SUBJECT: Transmittal of Revised Responses to AP1000 DSER Open Items

AP1000 Design Certification Review
Draft Safety Evaluation Report Open Item Non-Proprietary Responses

DSER Open Item Number: 19.1.10.1-5 (Response Revision 1)

Original RAI Number(s): 720.009, 720.012, 720.013, 720.014, 720.017, 720.021, 720.024, 720.025

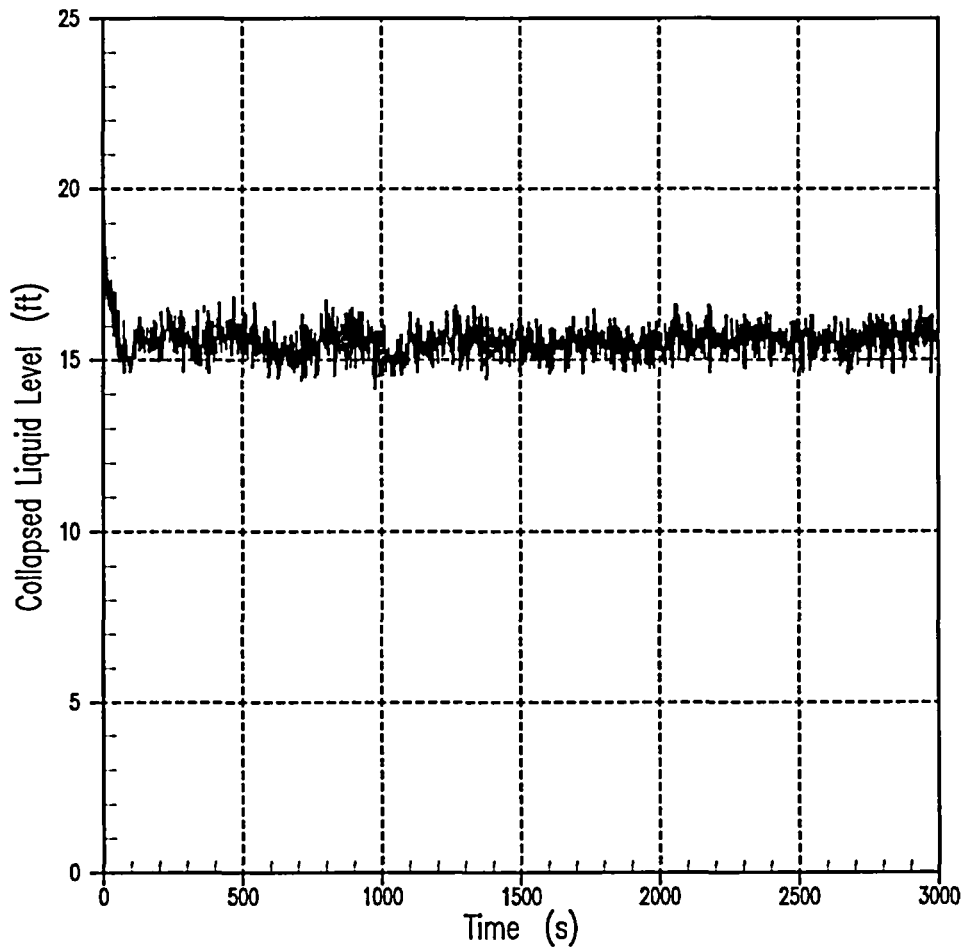
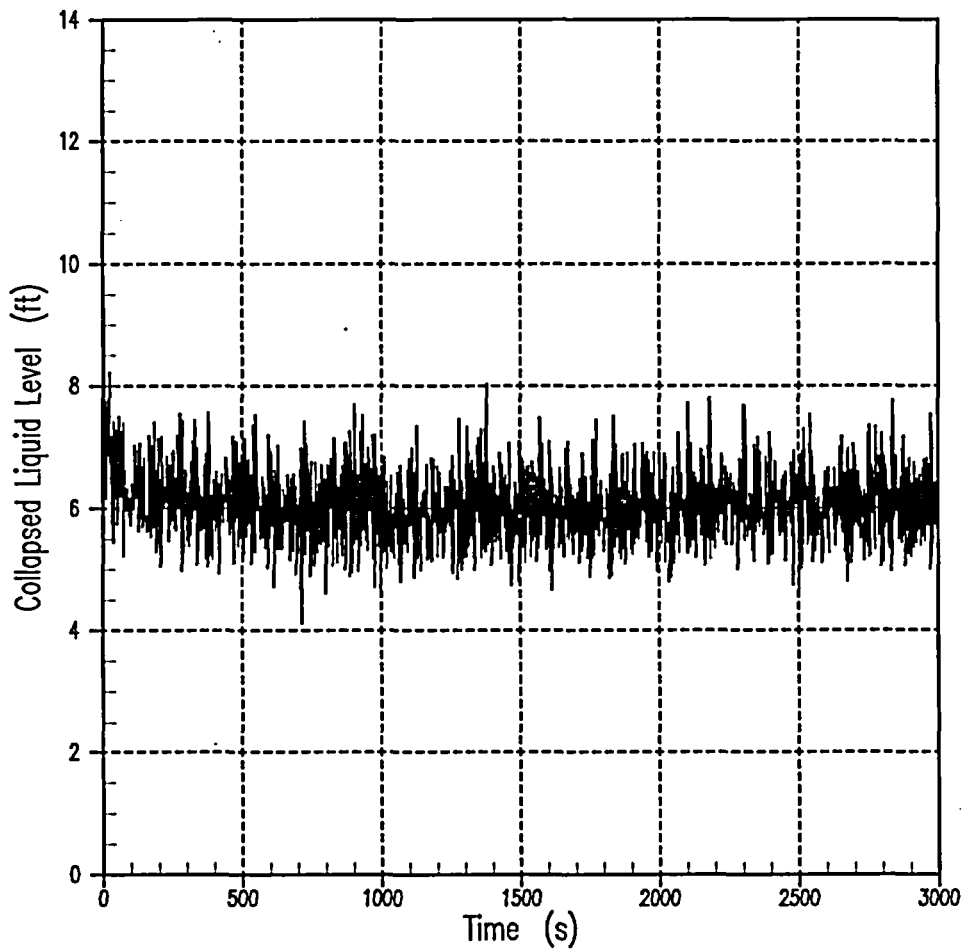
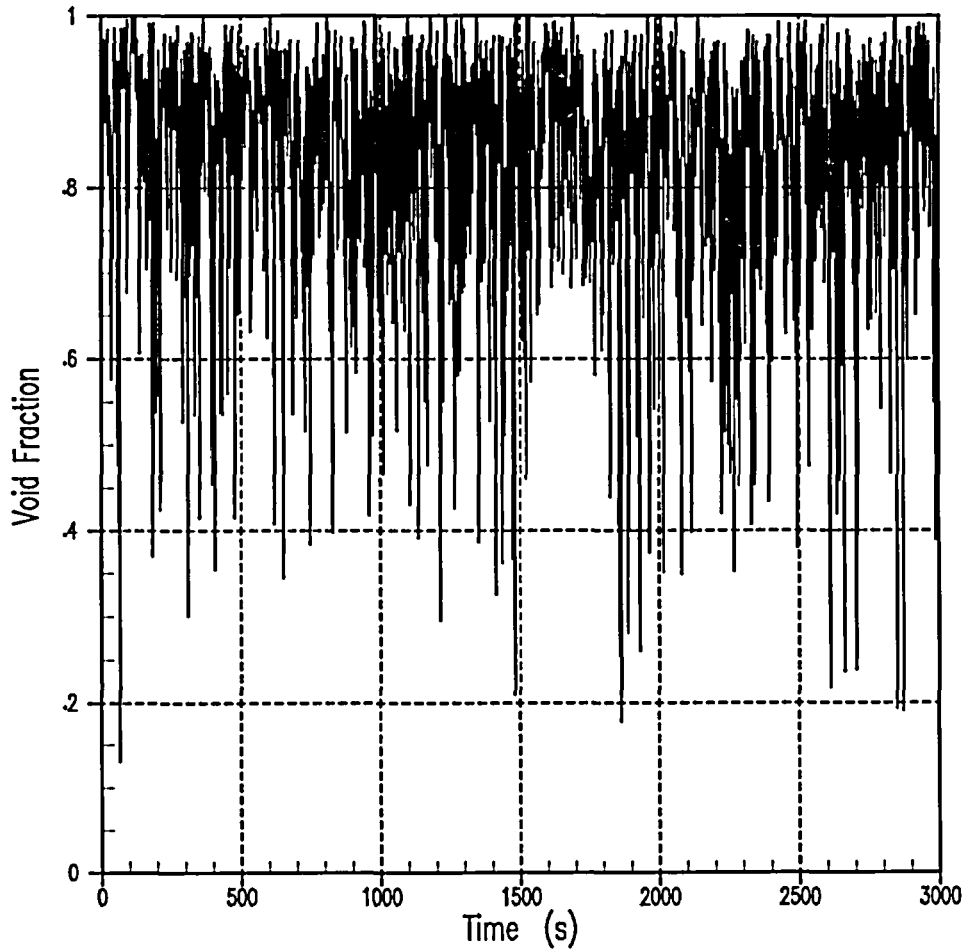
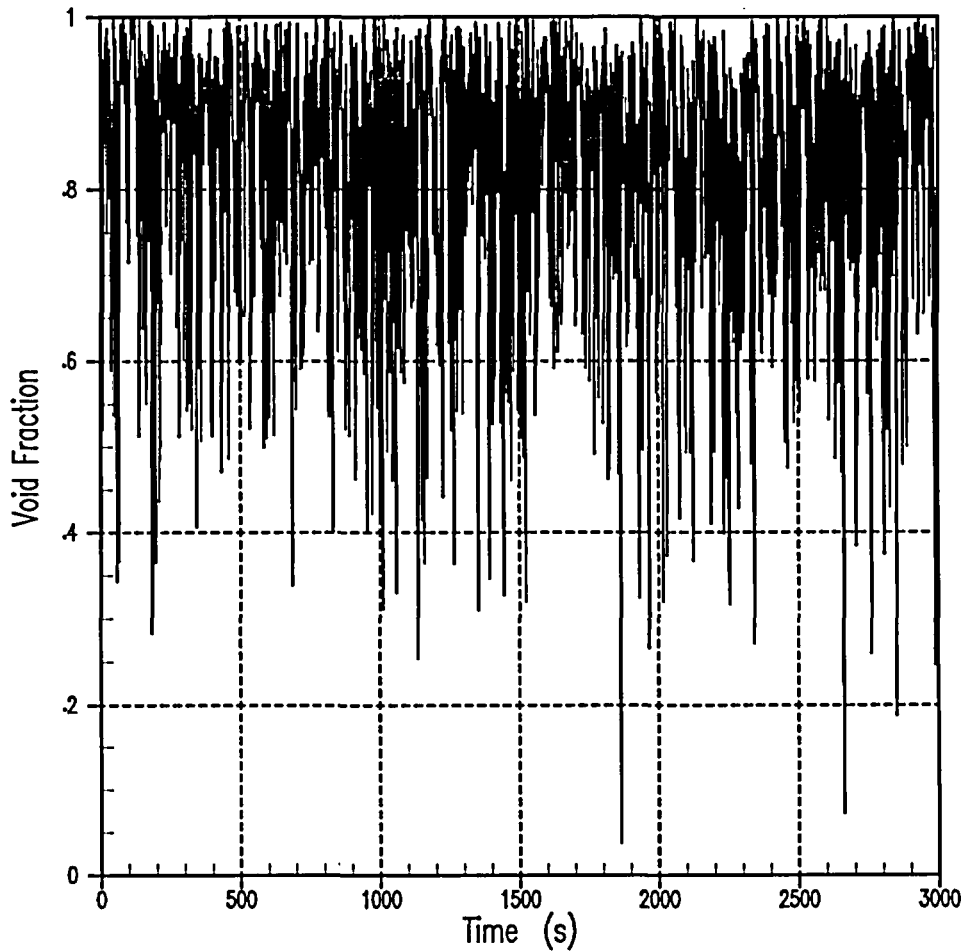
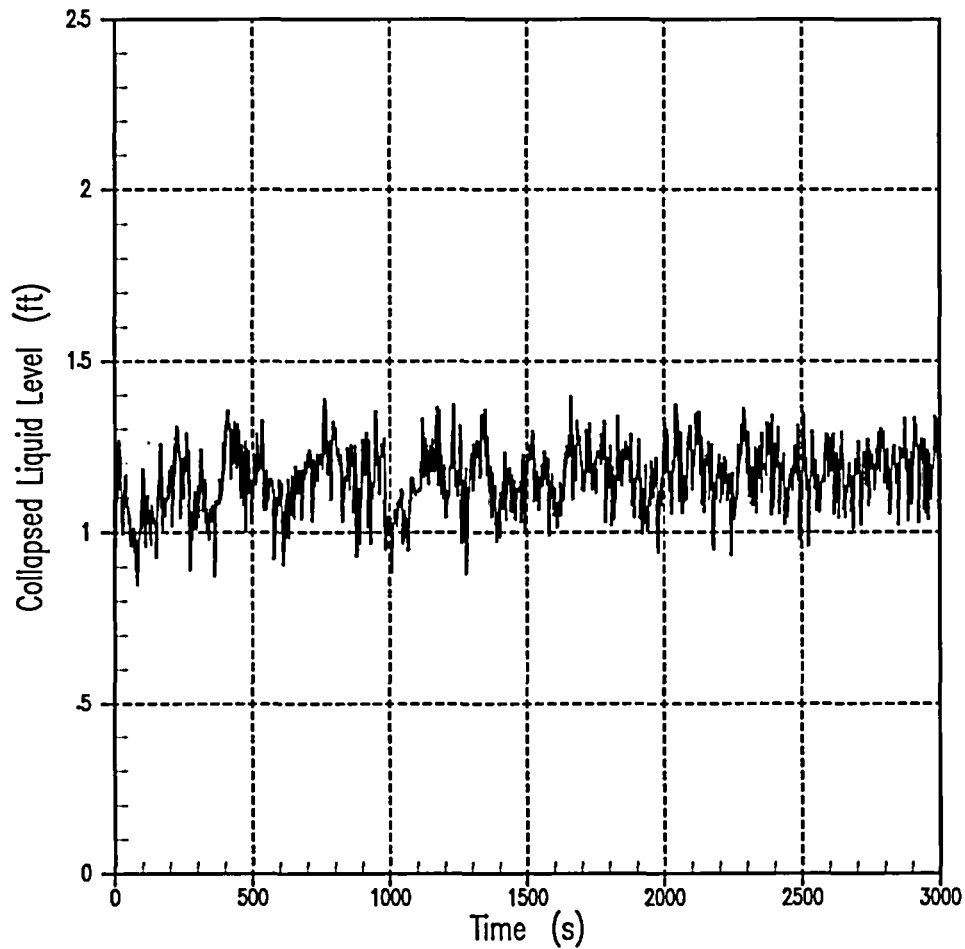
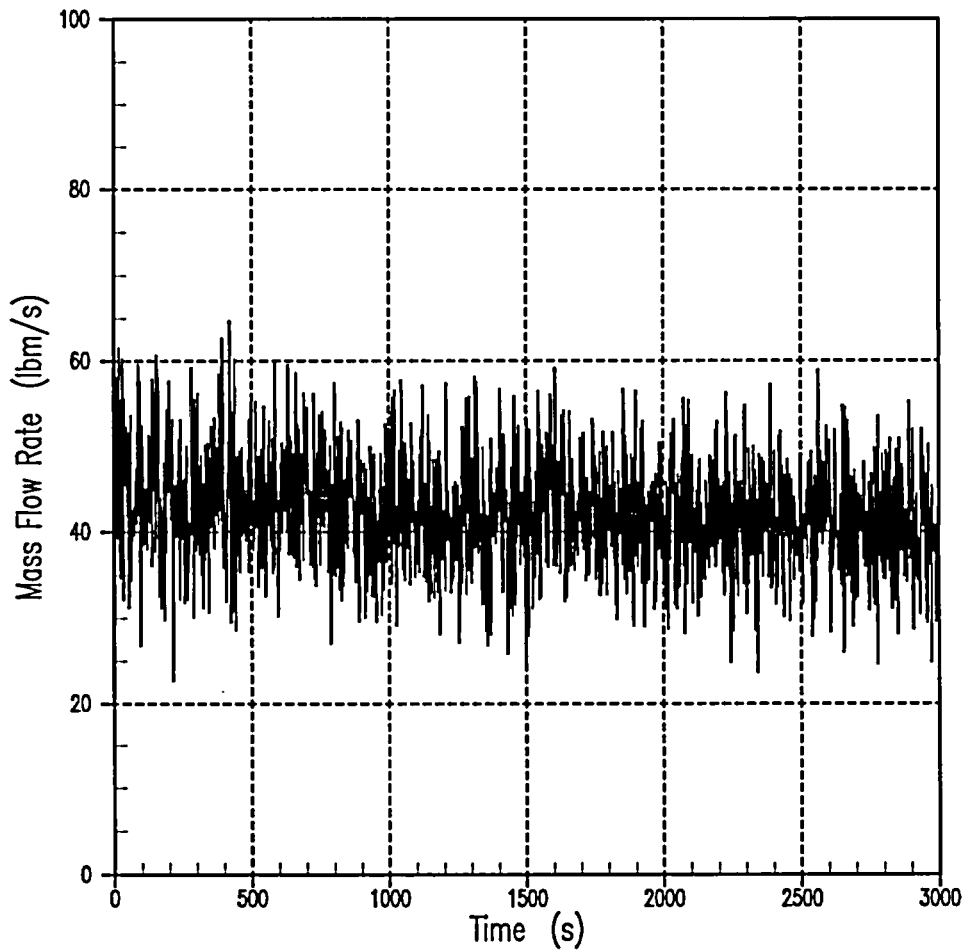
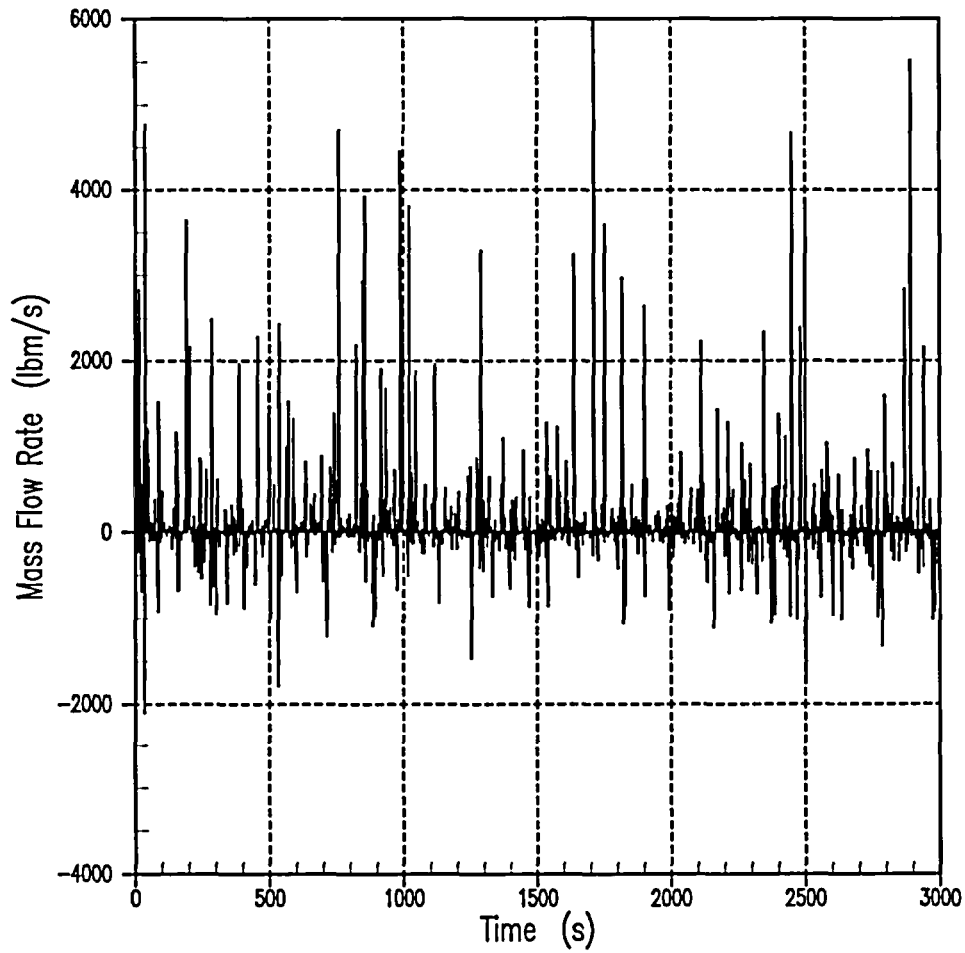
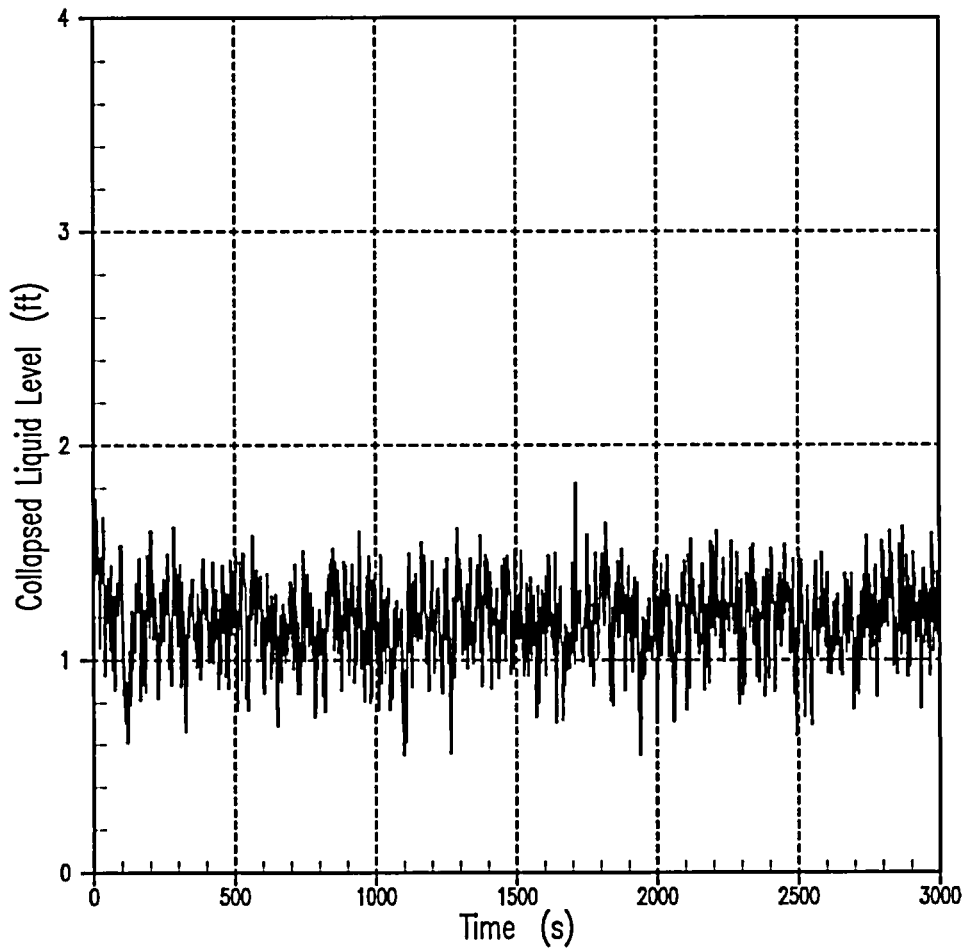
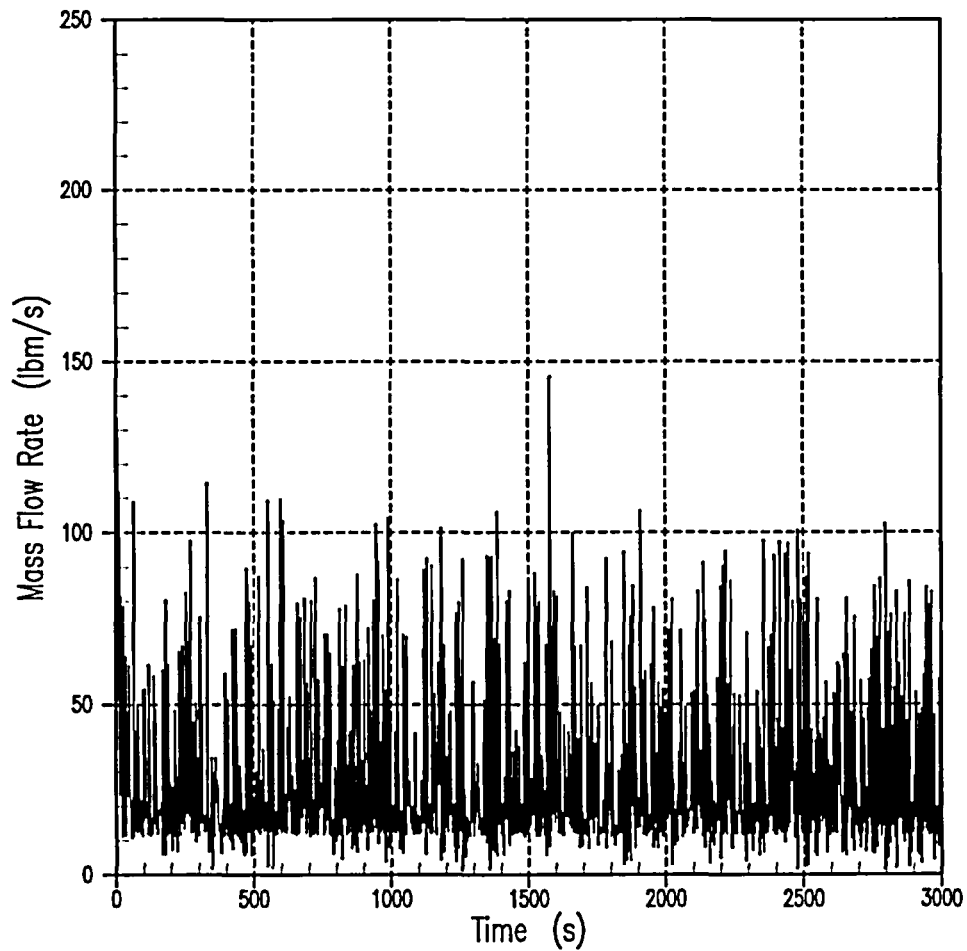
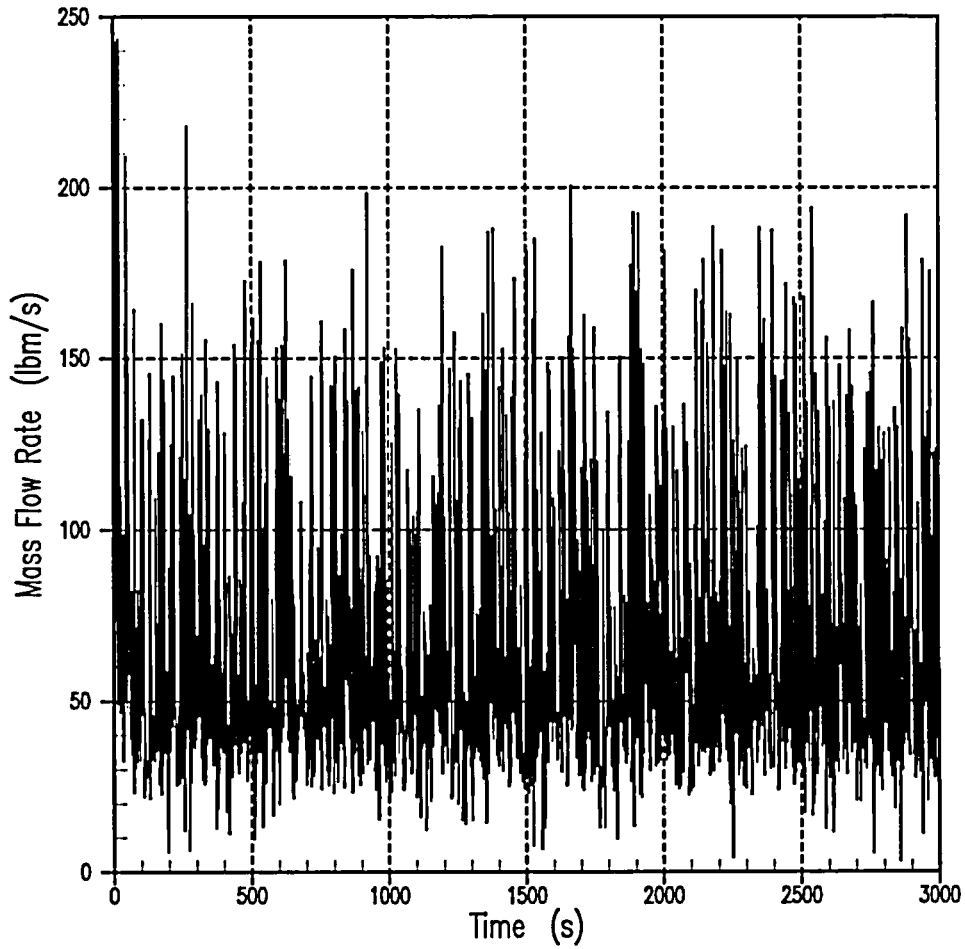
This issue remains open. In the revised response to RAI 720.013, Westinghouse performed long term cooling analyses for bounding conditions in the PRA. (Case F DEDVI, 1 CMT, 1 recirc line, 3/4 ADS4 and CI) and (Case G DEDVI, 1 CMT, 1 recirc line, 4/4 ADS4 and CI failure). The WCOBRA/TRAC code was used for LTC calculations with input conditions derived from MAAP4 analyses. As discussed in the DSER the staff has not reviewed MAAP4 except for its use in screening studies. These are analyses using minimum equipment sets as discussed in the DSER. The staff believes that only a methodology the staff has reviewed should be utilized. In addition, as a result of staff and ACRS questions, the WCOBRA/TRAC long term cooling model has been changed. The staff believes that the revised model should be used in these bounding calculations.

- (a) The long term cooling success criteria analysis case and the thermal hydraulic uncertainty cases F and G have now been performed using the revised WCOBRA/TRAC model and using input conditions from WGOETHIC. The revised cases replace the previous cases as shown below in the revision to PRA Appendix A.

Initially, the only injection comes from the IRWST into the reactor vessel through the intact DVI injection line (Figure A5.3-28). Since at the beginning of the analysis, the level in the PXS-B room is below the DVI injection nozzle elevation, only steam from the downcomer is vented out through the break. Water starts to flow back into the downcomer through the broken DVI line about 2 hours into the transient. This is the time when the level has about reached its minimum value in containment, yet decay heat is still relatively high in the PXS-B room becomes high enough to provide sufficient driving head for this to happen. This time, unlike the Case F DVI break scenario, the transition into reversed injection of water through the break into the downcomer occurs a little earlier, and is somewhat softer. As a result, the increased depressurization rate observed in Case F does not occur. Still, the levels in the downcomer (Figure A5.3-15), the reactor core (Figure A5.3-16) and the upper plenum (Figure A5.3-22) are maintained high enough by the available DVI injection to provide acceptable core cooling.

The availability of all ADS Stage 4 valves provides enough venting capacity to assure adequate depressurization and successful performance of the passive safety systems (Figures A5.3-23 and A5.3-24). The fuel remains covered throughout the transient, and adequate core cooling is provided to remove the decay heat. The hot rod cladding temperature at the top of the core is about 20°F above saturation (Figure A5.3-26) and steadily decreasing.
